City of Richmond

Re: Request for Proposal 4080Q – Janitorial Services - Watermania- Addendum 1

SHEET 131
AREA 'B' FLOOR PLAN

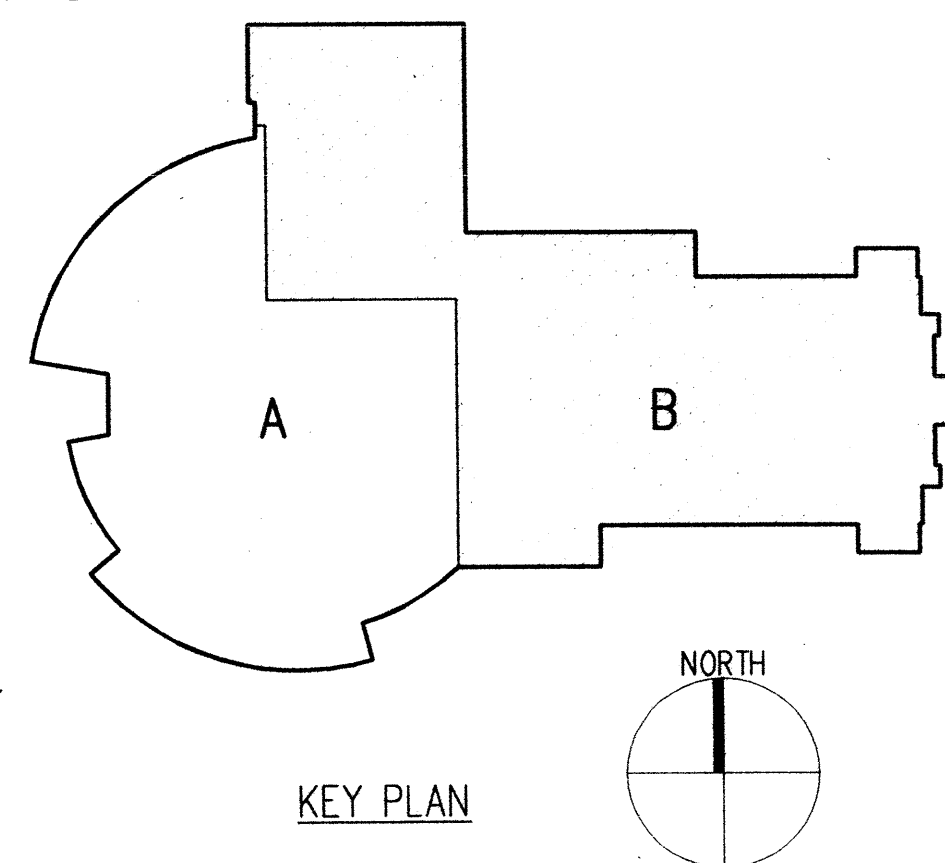
Q1) Can I have a floor plan and total square footage of the Watermania complex ? Does this square footage just cover the cleanable areas ?

A1) Please see attached. The total square footage of the building is 74,000 sq ft. This is the entire building and includes cleanable and non-cleanable areas. Cleanable square footage is 57,000 sq ft .
